SERVICE BULLETIN

SERVICE BULLETIN NO: 53-007 REF NO: 59

FUSELAGE ENGINE MOUNTING-FRAME ATTACHMENT-FITTINGS - INSPECTION

Engine Mount Attachment Fittings - Inspection/Repair Figure 1

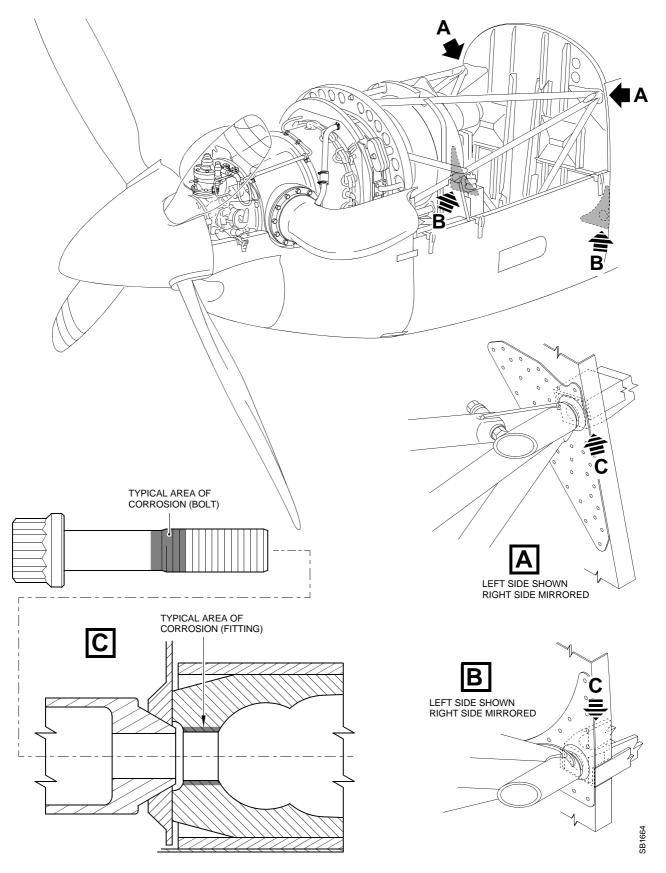
A. Inspection/Repair (Ref. Fig 1)

- (1) Remove the bolt and washer from one of the four engine mounting-frame attachment points (Ref. AMM 71-20-01, Page Block 401).
- (2) Do a visual inspection for corrosion on the removed bolt.
- (3) Do a visual inspection for corrosion in the bore of the attachment fitting. Do this with a boroscope. If you find corrosion, do the subsequent steps:

- (a) Use aluminum wool (Material No. P02-002) to remove surface corrosion.
- (b) If you cannot remove all of the corrosion contact Pilatus for repair information.

- (c) Clean the bore and the threads of the barrel nut with solvent (Material No. P01-008) and absorbent paper (Material No. P02-031).
- (d) Remove all swarf and debris from the attachment fitting. If necessary, you must remove the barrel nut and/or the engine mounting frame to do this. Make sure there is no swarf and debris in the joints between:

- · The attachment fitting and the barrel nut
 - The attachment fitting and the engine mounting frame.
- (e) Apply a layer of CCC solution (Material No. P07-001) to the bore.

- (f) If necessary, install the barrel nut and/or the engine mounting frame.
- (4) Install the new bolt (P/N 571.20.09.031) and the washer (P/N 938.75.11.105) (Ref. AMM 71-20-01, Page Block 401).
